Re: California Waterfowl Association Comments on the Draft EIS/EIR on Proposed Long-Term Water Transfers

RE: Central Valley Project Long-term Water Transfers Draft Environmental Impact Statement/Environmental Impact Report

Figure 1. Normalized Stream Depletion Curve. (from TNC 2014, normalized to the simulated amount pumped in one season.)

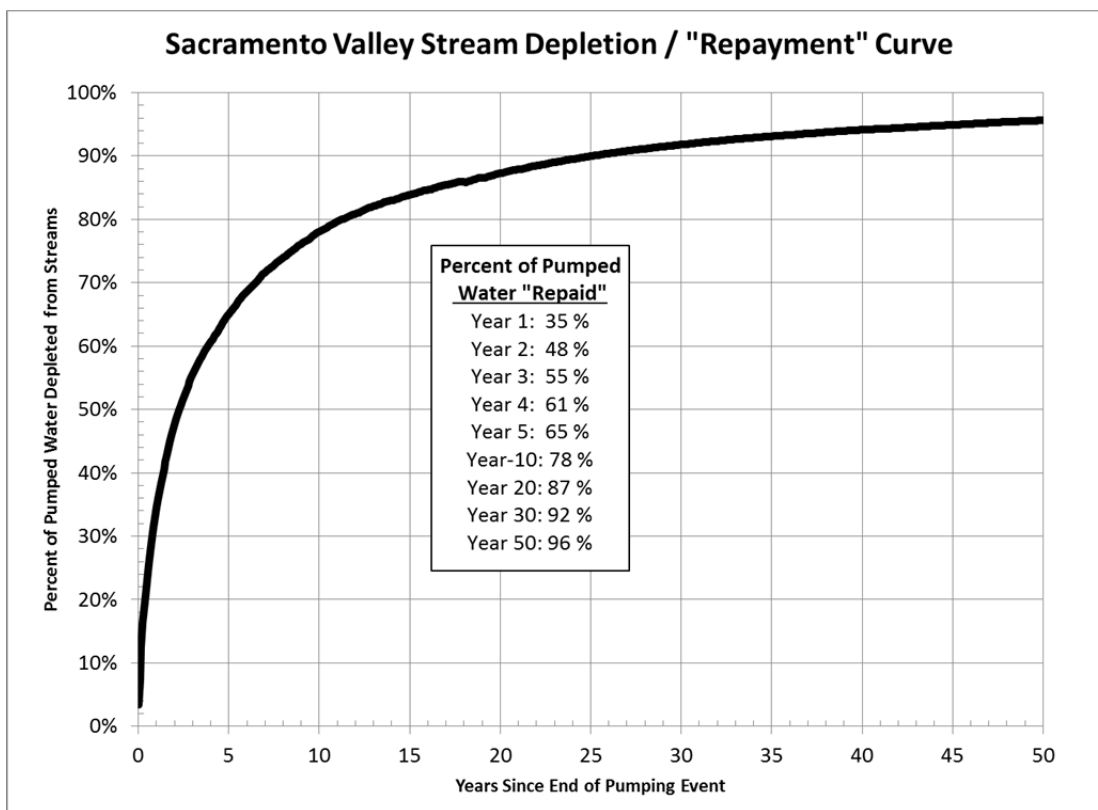
Simulations performed by TNC using DWR’s C2VSim integrated ground and surface water model of the Central Valley indicate that groundwater pumping at scales similar to the Proposed Action affects a large area and, very importantly, that streamflow depletion from even a single year of such pumping persists for decades⁷. The timing of these impacts is illustrated in Figure 1, below.

Figure 1 shows that streamflow depletion is significant for many years after pumping has ceased, with only about 65 percent of ultimate stream depletion expressed even 5 years after pumping has stopped. It takes 25 years for the system to nearly fully “recover” (90 percent “depletion recovery”). Although different assumptions regarding well locations and depth will lead to differently shaped depletion curves, the best information available suggests that impacts from pumping will persist for decades for wells distributed over wide areas and depths, as is the case for the Proposed Action. In contrast, Figure 3.1-3 of the EIS/EIR does not reflect this full duration of impact, at least as expressed in percent changes in CVP and SWP exports. Please explain how the modeling done for this Draft EIS/EIR accounts for the compounding impacts to water supplies from multiple years of pumping, and how the duration of impact through full recovery will be accounted and mitigated under Mitigation Measure WS-1.

To appropriately characterize the potential water supply and environmental impacts of the Proposed Action, the Draft EIS/EIR must more clearly answer the question, “Which streams are likely to be depleted, by how much, and for how long?” The EIS/EIR needs to better account for the source of pumped water and its related cumulative impacts over time to both water rights holders (both export rights and in-valley rights) and the environment, and avoid or fully mitigate for those impacts. To fully mitigate for groundwater substitution pumping impacts on water supplies, Section 3.1.4.1, *Mitigation Measure WS-1, must describe in detail how the streamflow depletion factor will be developed, account for compounding, and be applied over the duration of the project and beyond until recovery is achieved.*
